Description of Permissive Change

Report No.: RF960522L15A

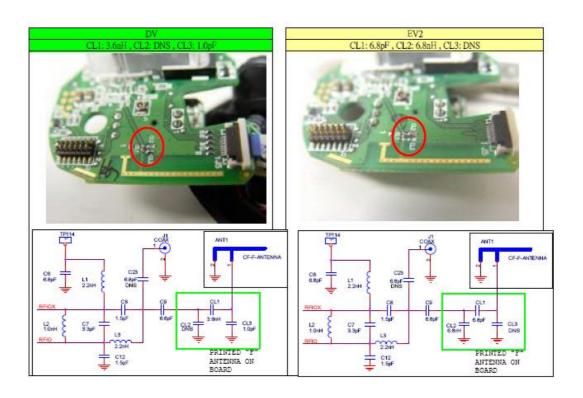
This report is prepared for FCC class II permissive change. The differences compared with the original are some component changed for antenna matching.

ITEM	ORIGINAL DESCRIPTION	ITEM	CLASS II CHANGE DESCRIPTION
1	CL1: 6.8pF	1	CL1:3.6nH
2	CL2: 6.8nH	2	CL2: DNS
3	CL3: DNS	3	CL3:1.0pF
